PCC PAVEMENT - GRADE AND REPLACE  
IMX-080-5(390)147--02-77

# PLANS OF PROPOSED IMPROVEMENT ON THE INTERSTATE ROAD SYSTEM POLK COUNTY PCC PAVEMENT - GRADE AND REPLACE

Rest Area I-80 near Mitchellville (EB)

**PRELIMINARY PLANS**

**AUTO PARKING LOT**

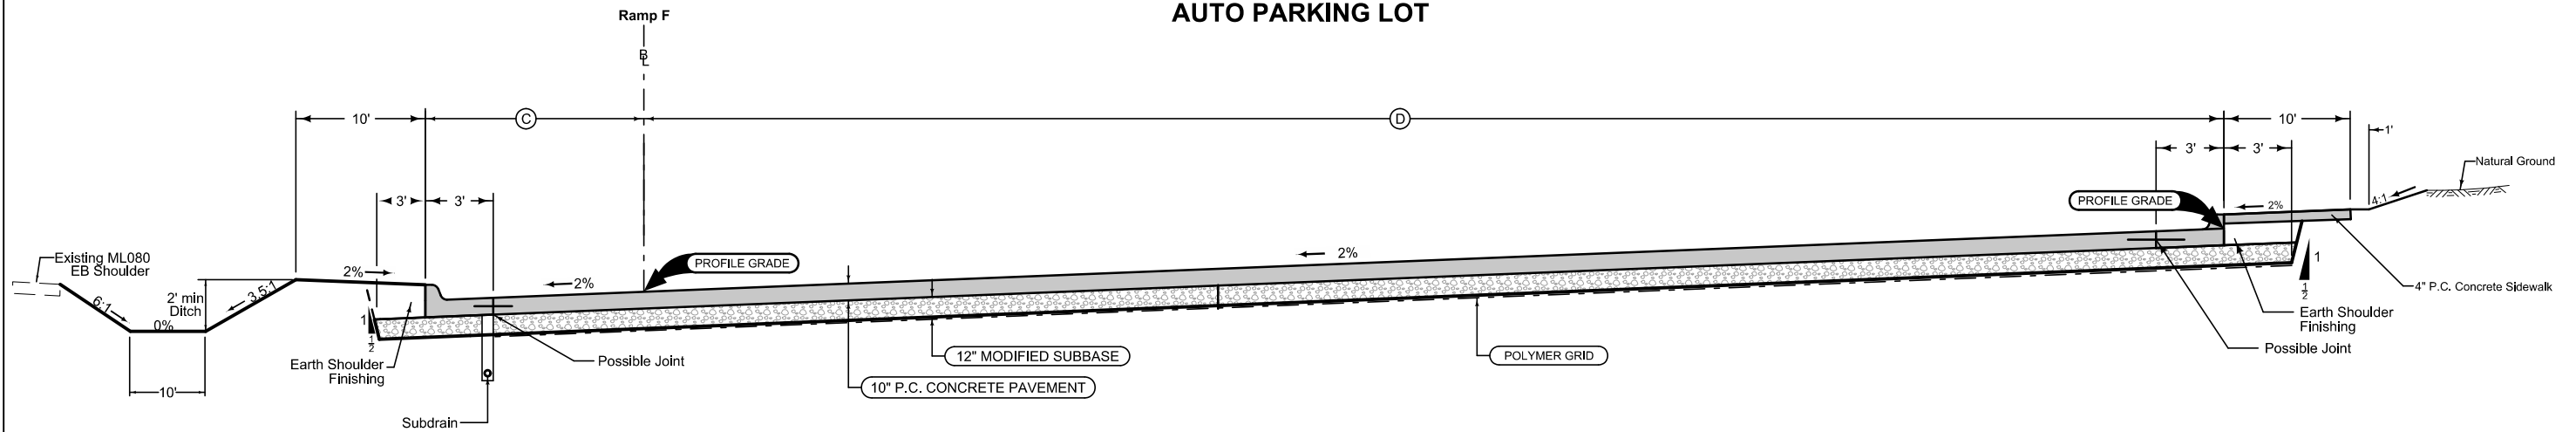
Confirm locations of polymer grid, including under auto parking lot.
